P. O. A. D. P.
NORTH VALLEY SUBDV.
UNITS 14, 15, & 16
SAN ANTONIO, TEXAS

INFORMATION SHEET FOR
PRELIMINARY OVERALL AREA DEVELOPMENT PLAN
(P.O.A.D.P.)

RE: North Valley P.O.A.D.P.
File #86-11-60-66

RE: NORTH VALLEY UNIT-14

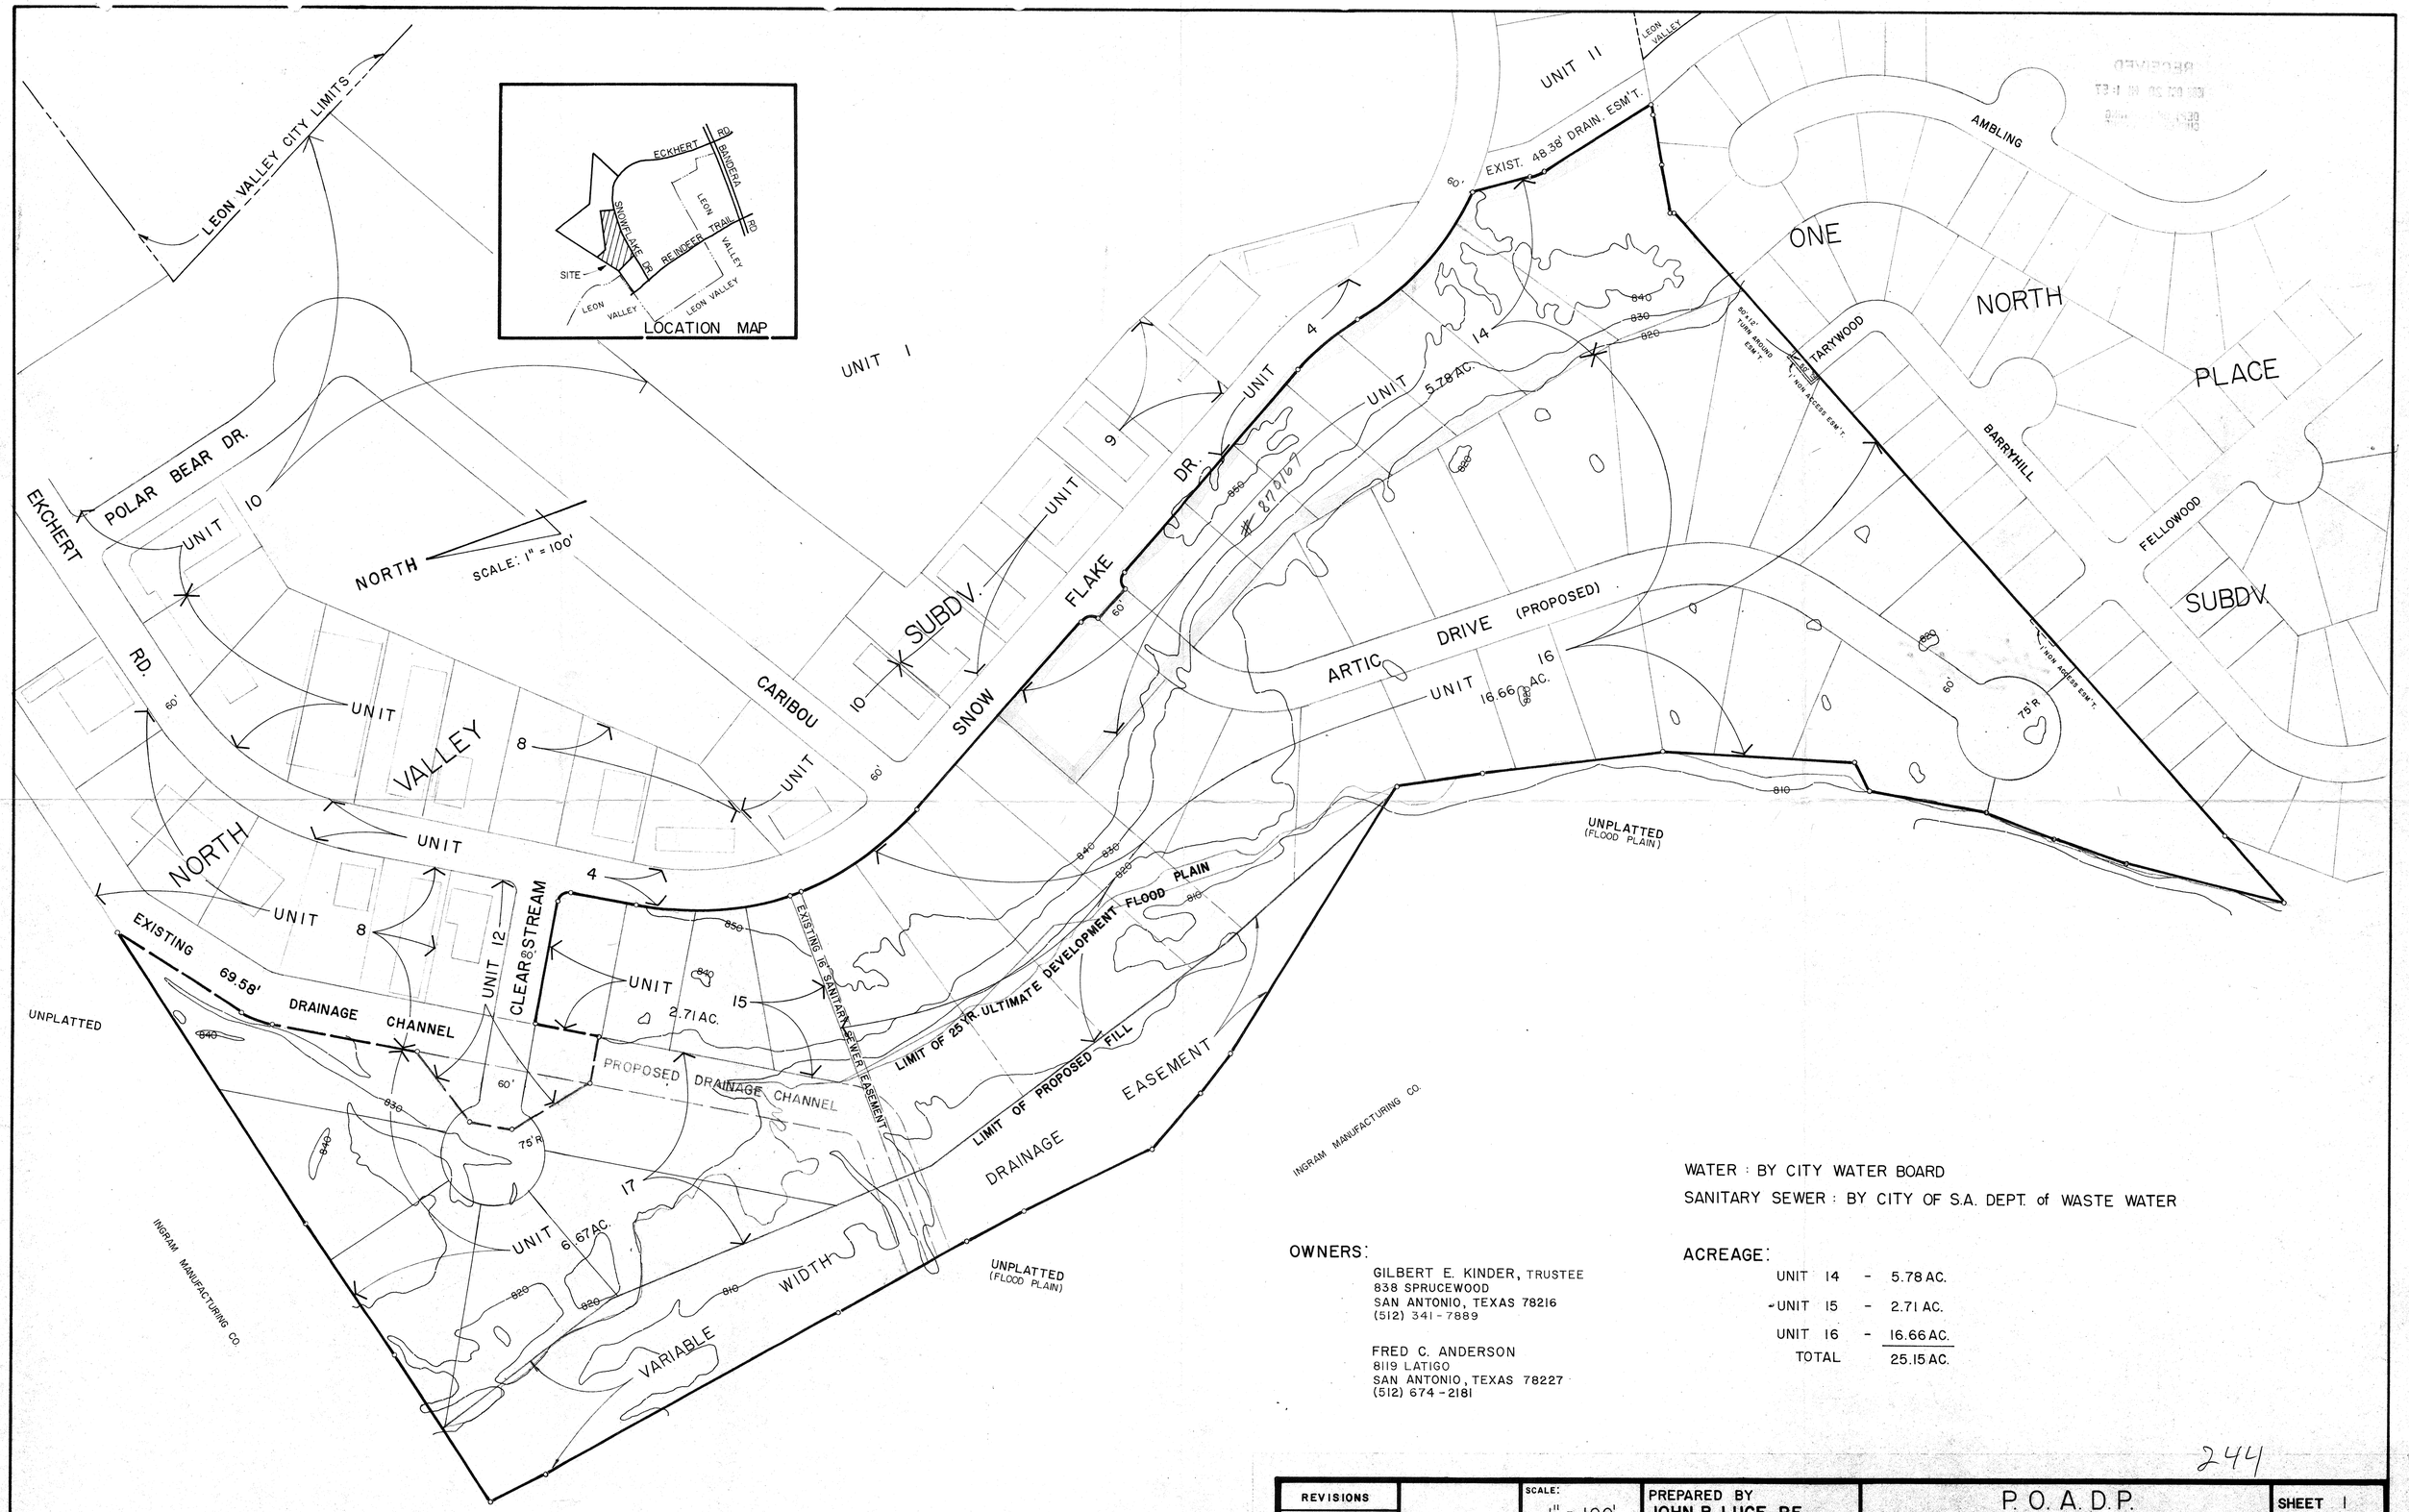
Committee comment:

(a) show city limits line

(b) Land use

(c) acreage

a 1' vehicular non-access esmt will be required where Fellowood Dr. ends. Also, need to work with Traffic for a short turn-around or stub for turning will be required along with a 1' vehicular non-access esmt. for Tarrywood Dr. In addition, traffic is willing to allow a turn around with a 75' radius instead of the 100' radius. This however, will require a variance upon platting.
